Design Review Board Agenda

June 21, 2018

**CITY OF MILL CREEK
DESIGN REVIEW BOARD
APPLICATION PL2018-0005**

NAME OF PROJECT: Canyon Creek Church

Attachment 2 - Floor Plan

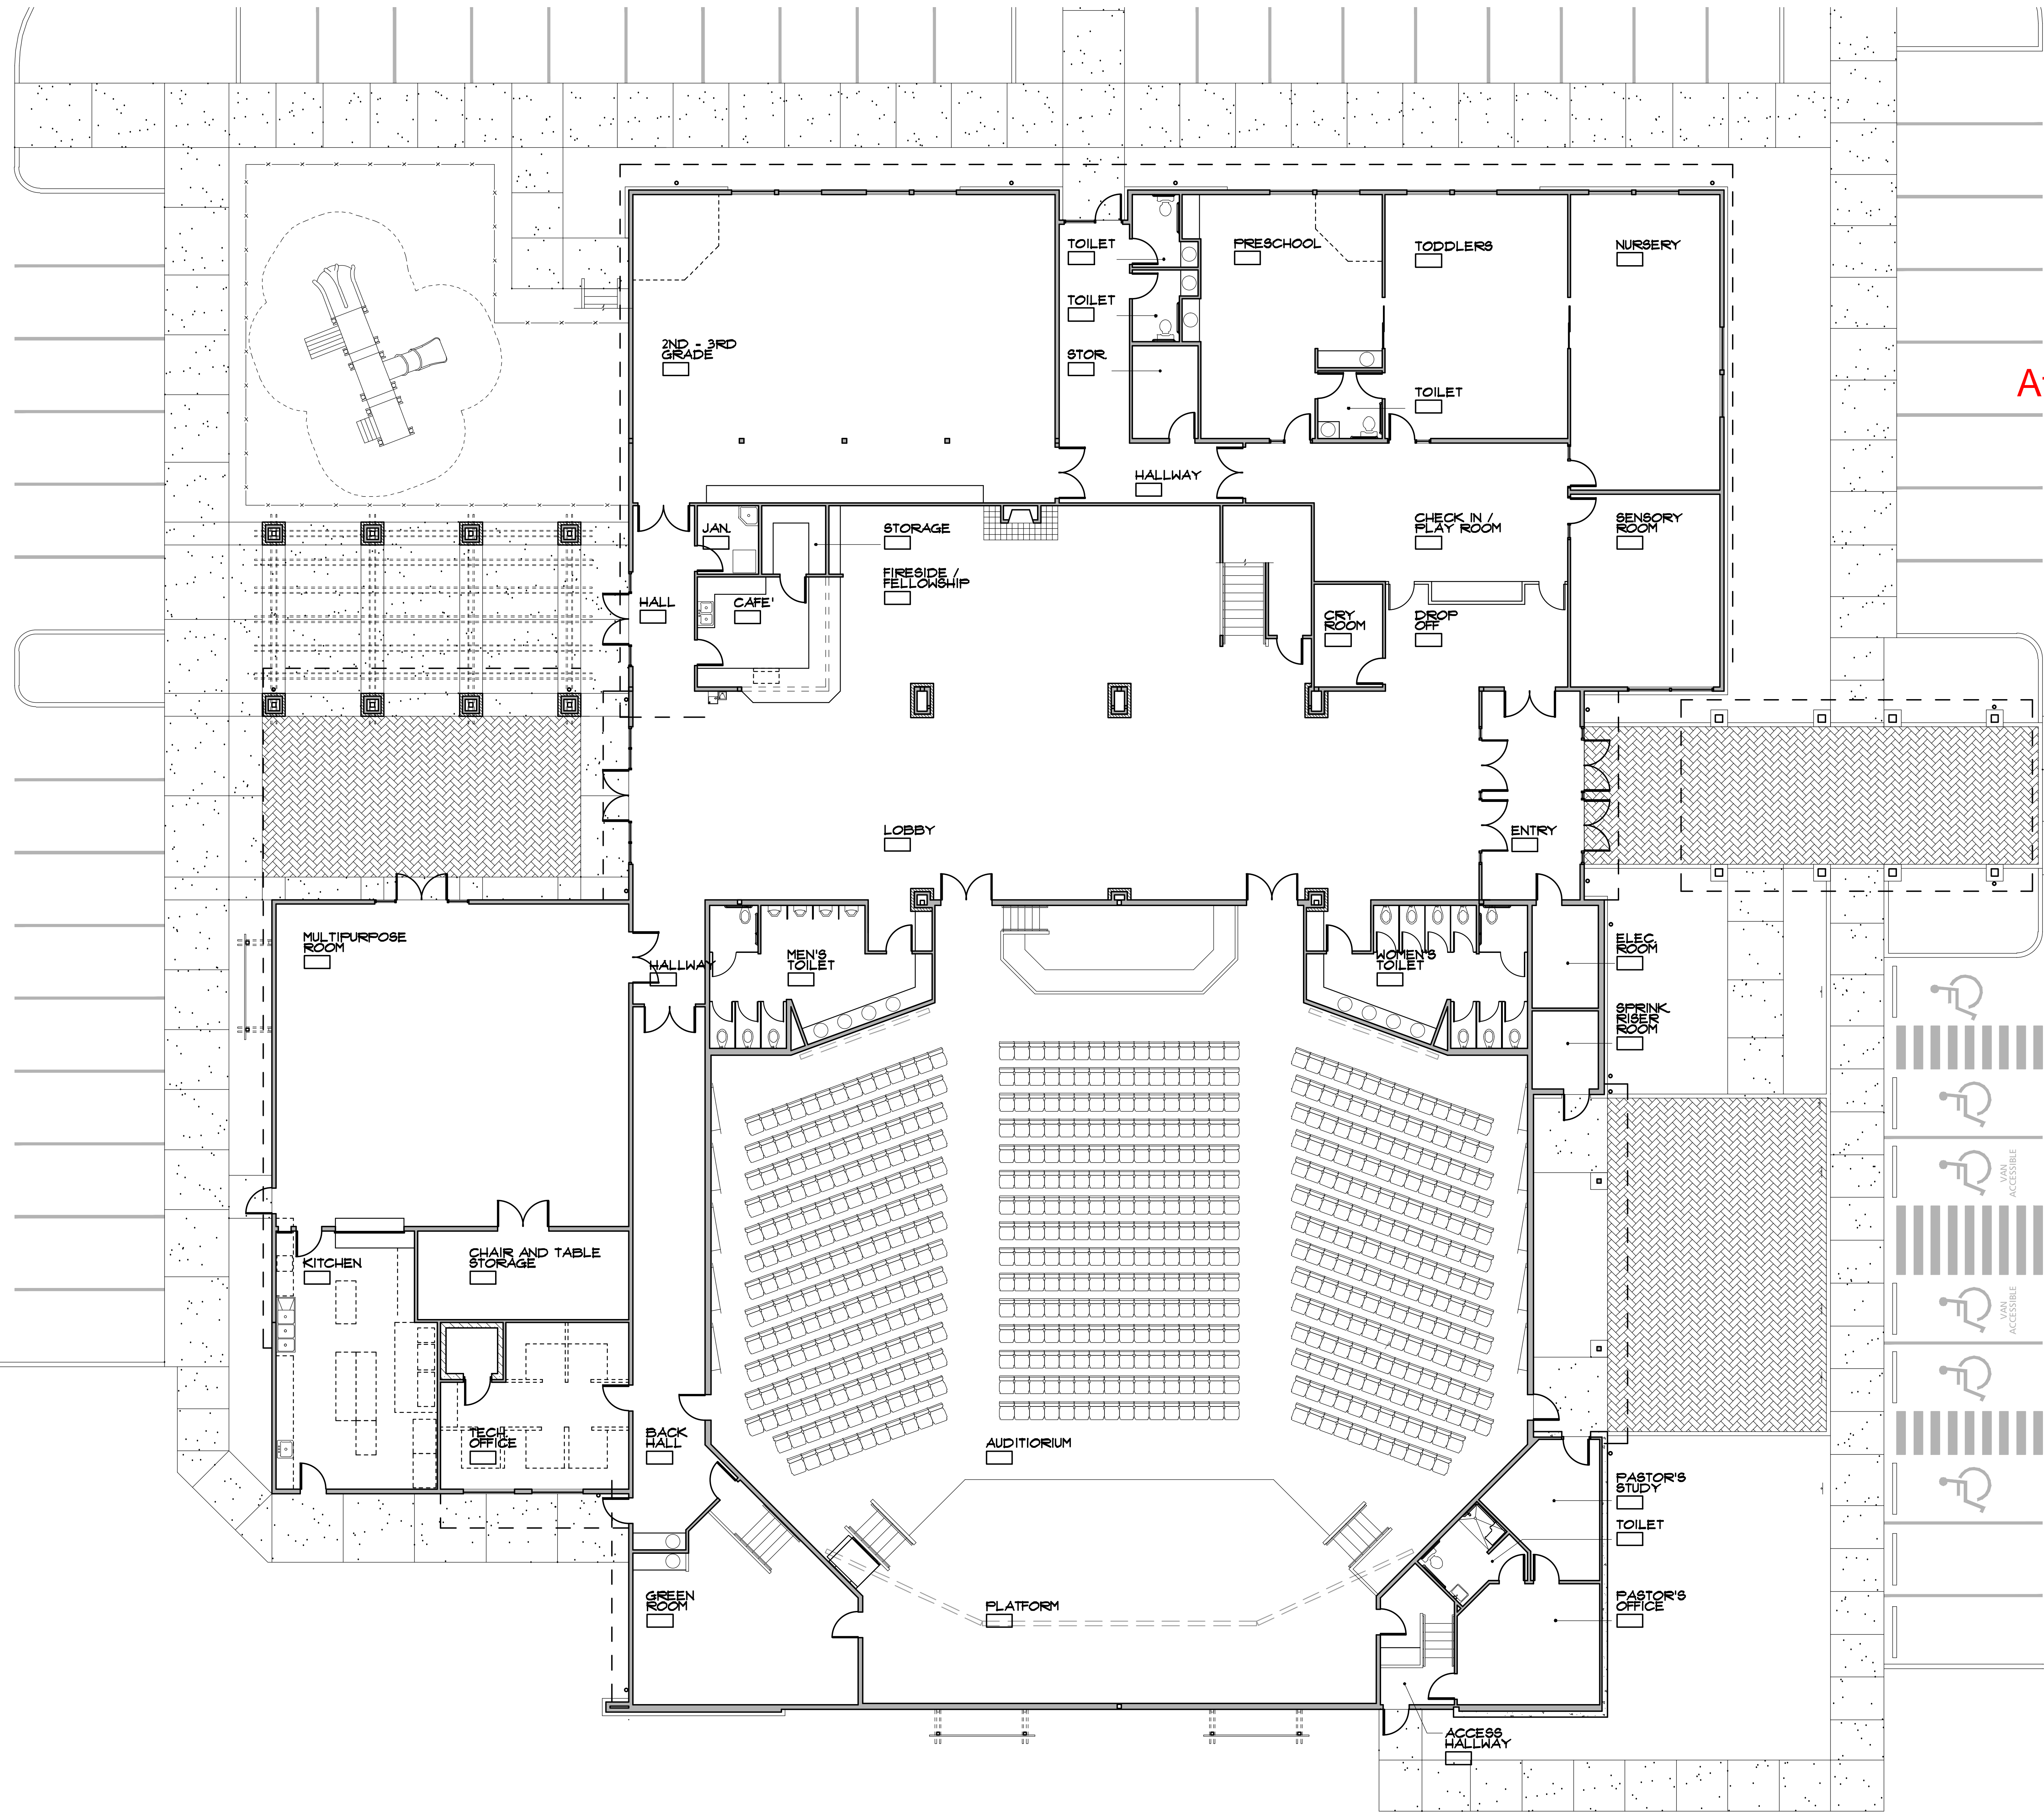
At the entry to the patio and foyer, the applicant is proposing to place outdoor tables and chairs as depicted on **Attachment 1 – Site Plan**, consistent with the open spaces and pedestrian walkway requirements of the Code.

Attachment 3 - Color Elevations

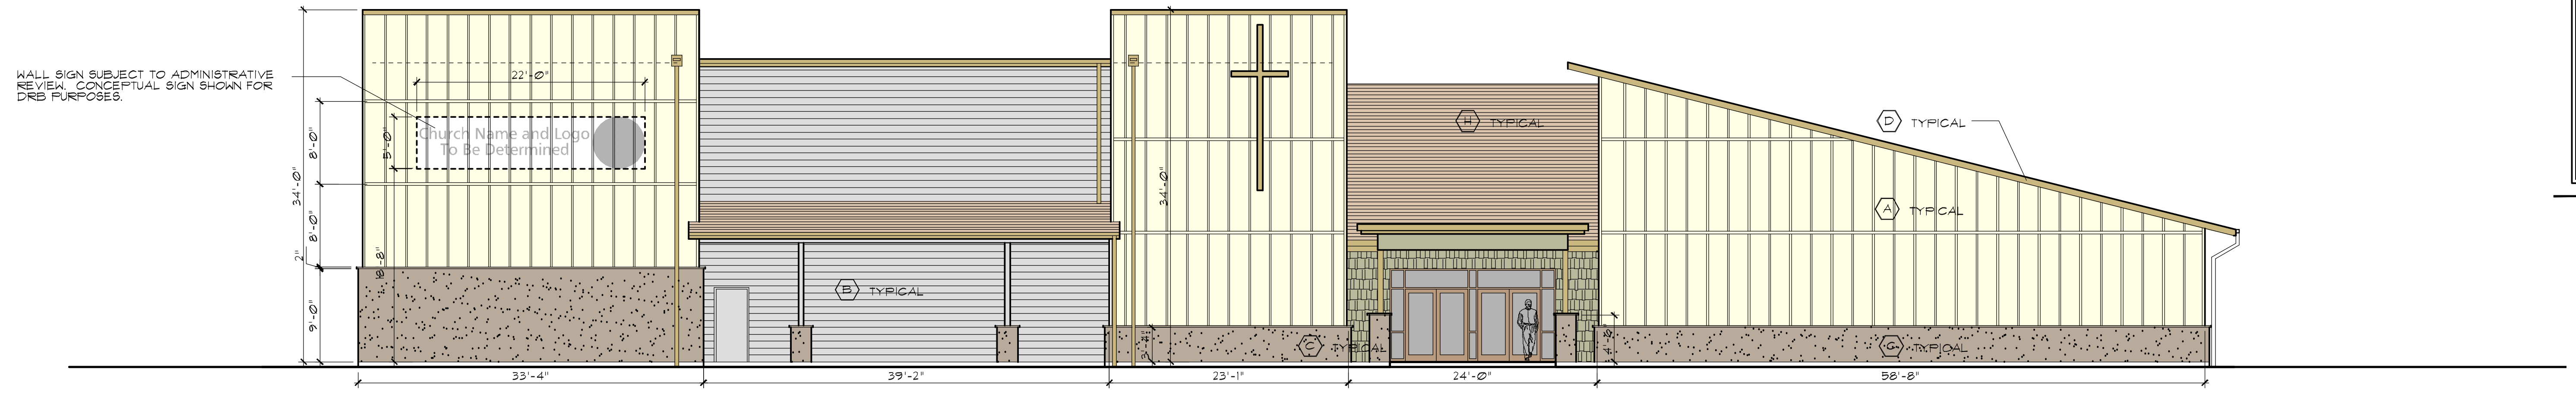
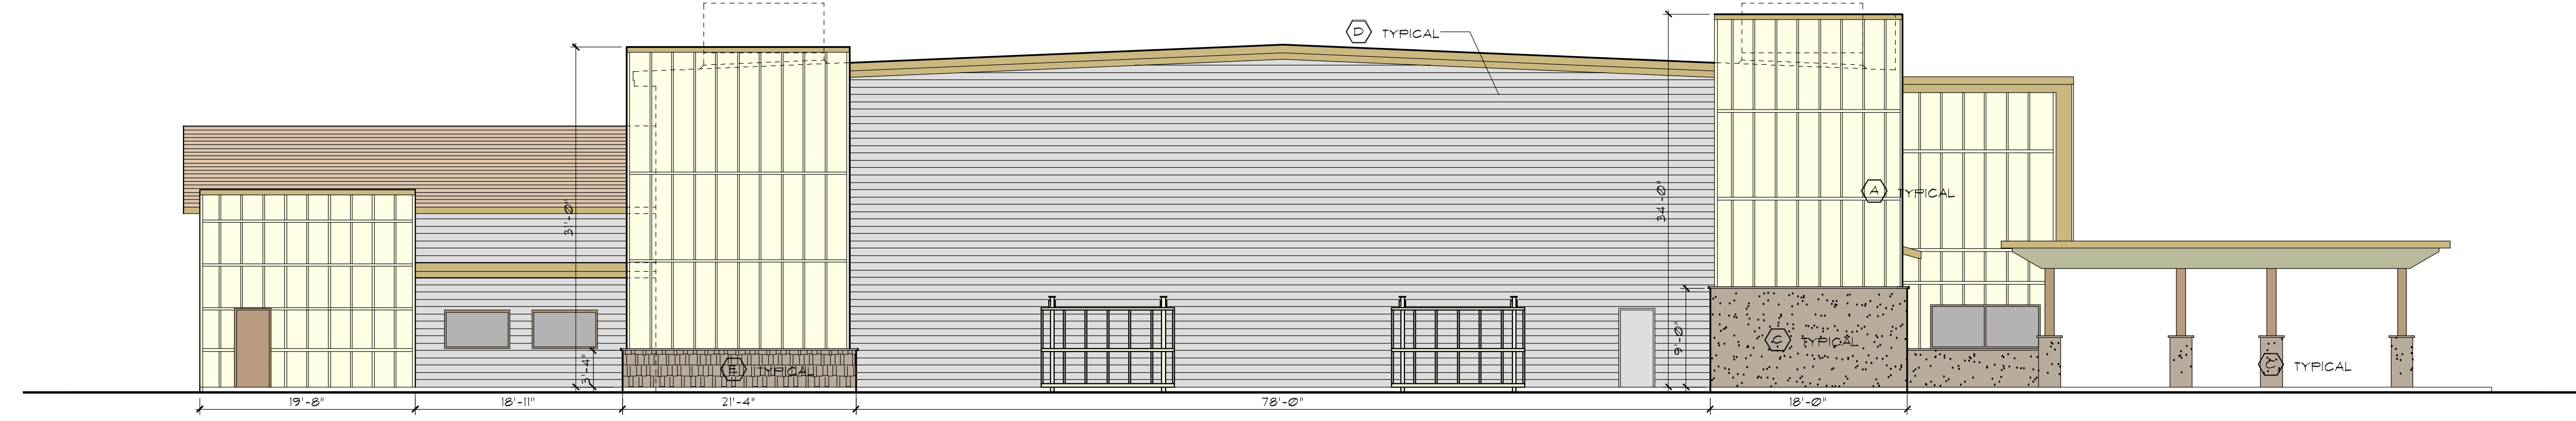
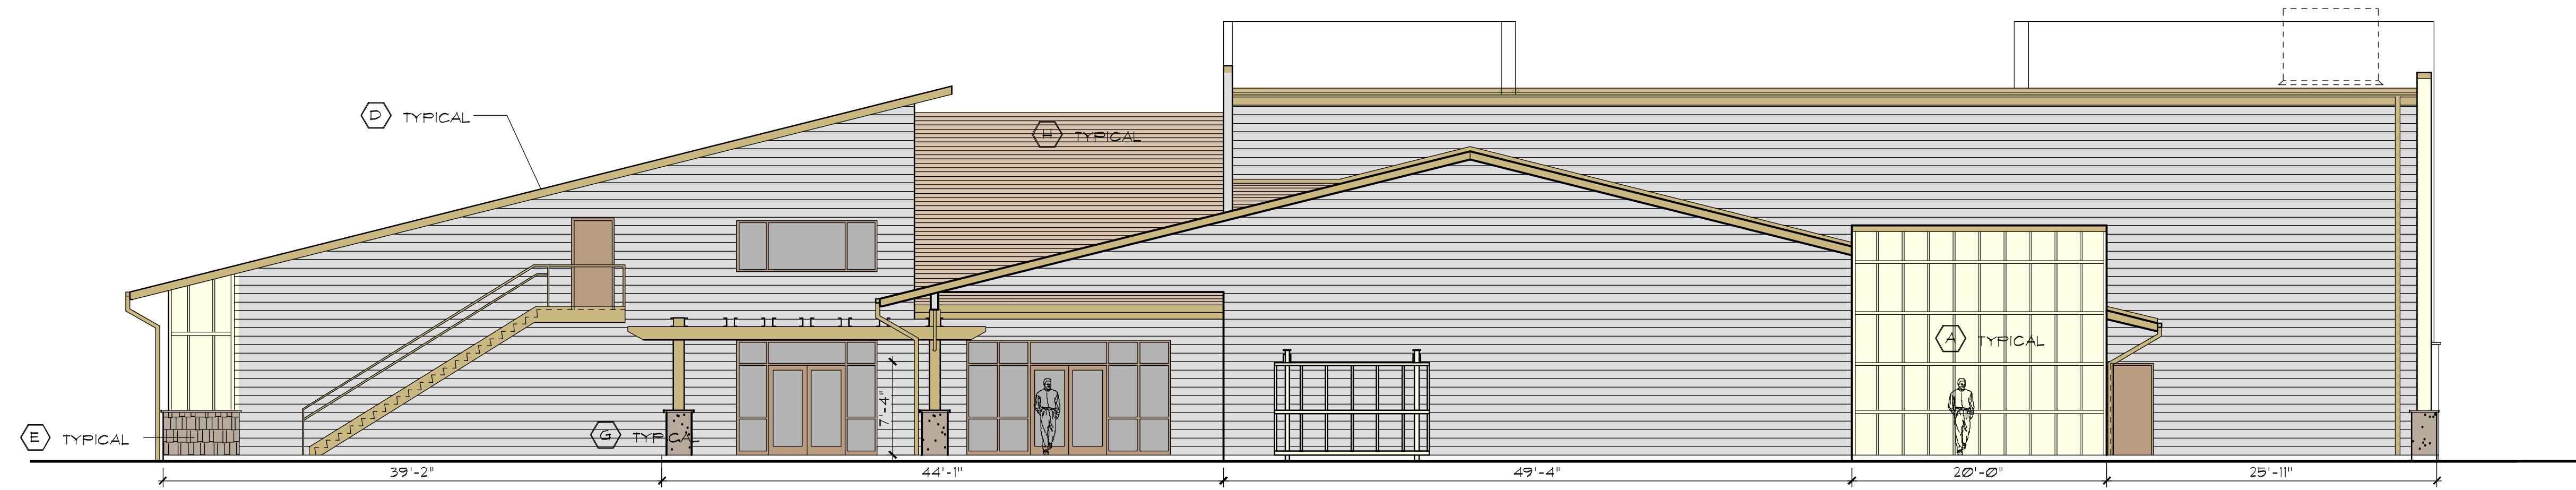
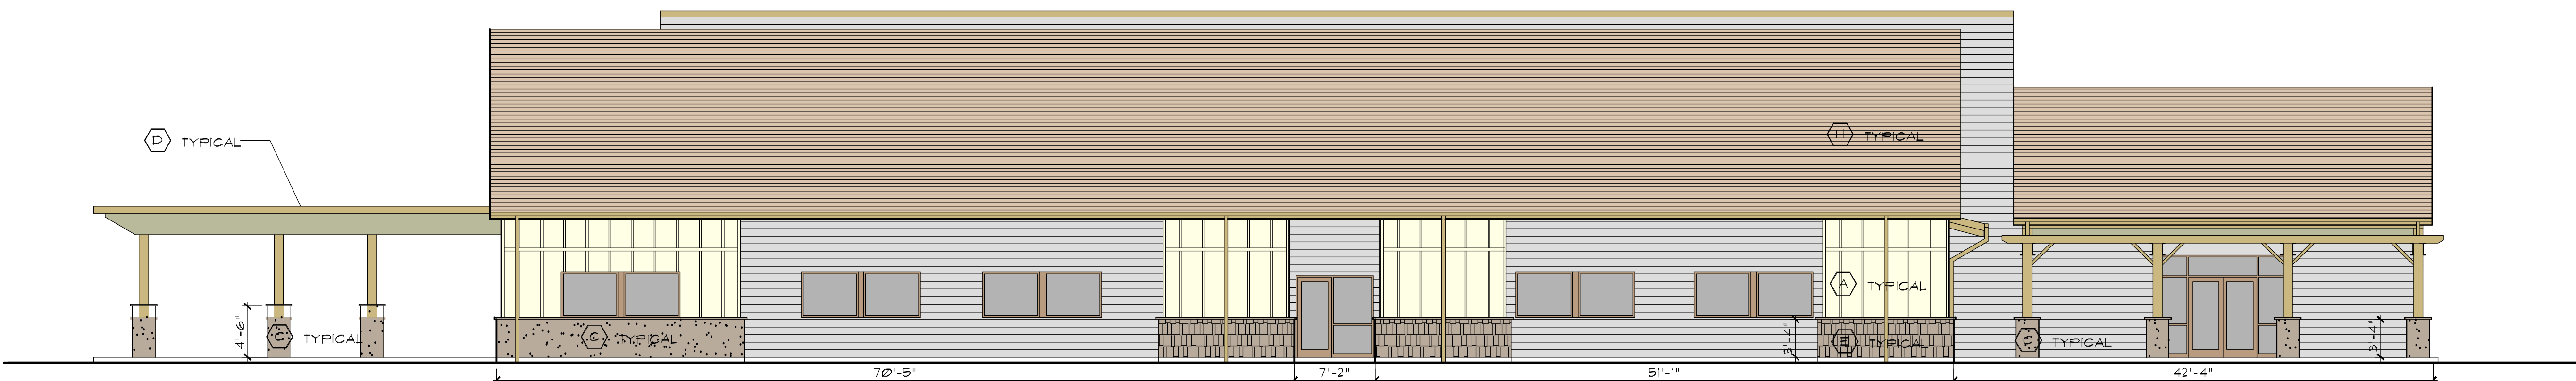
The applicant has addressed the DRB concerns (listed in the Background section of this report) on the northern façade by flipping the layout of the building and screening the rooftop equipment. In addition, the applicant did provide a break-up in the western façade on the 49 foot wall by adding a trellis, and on the southern façade the applicant is proposing to break-up the 79 foot wall with two trellises. The applicant is proposing to plant these three trellises with Climbing Star Jasmine.

The rooftop mechanical equipment will be screened from view from the public right-of-way by the building parapet.

As proposed, staff believes that the building elevations are in compliance with the design guidelines contained in the Code and is recommending approval with the Condition of Approval that the applicant add Climbing Star Jasmine to the Landscape Plan planting legend.

2. Amend the landscape plan as follows:
 - Add Climbing Star Jasmine to the plant legend to be planted on the building trellis's on the western and southern facades.
